Re: Sydney Metro West SSI-22765520 – GPT Submission

Figure 2: Central Urban Park and reliance on GPT land for activation

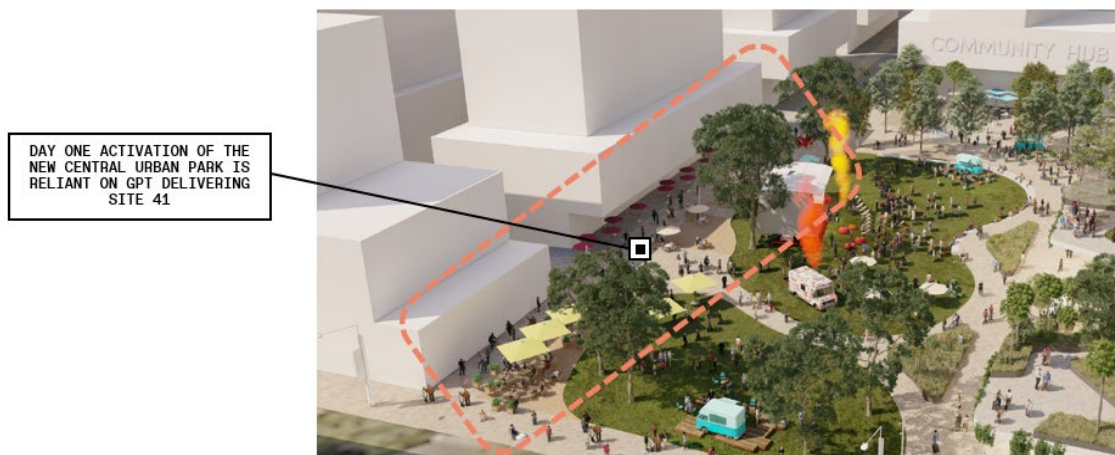
The eastern edge of the new open space to be provided in the north-east (Central Urban Park) is located on GPT’s leasehold (6 Herb Elliot Ave / Site 41). There are however no details or clarity around expectations and timing for when this area of Park is to be delivered. If there is a desire to have this Park activated in line with day one operations of the future Metro, then this eastern portion of the park will be important to delivering this precinct (as depicted in **Figure 2** prepared by SOPA in support of the proposed Interim Master Plan Update).
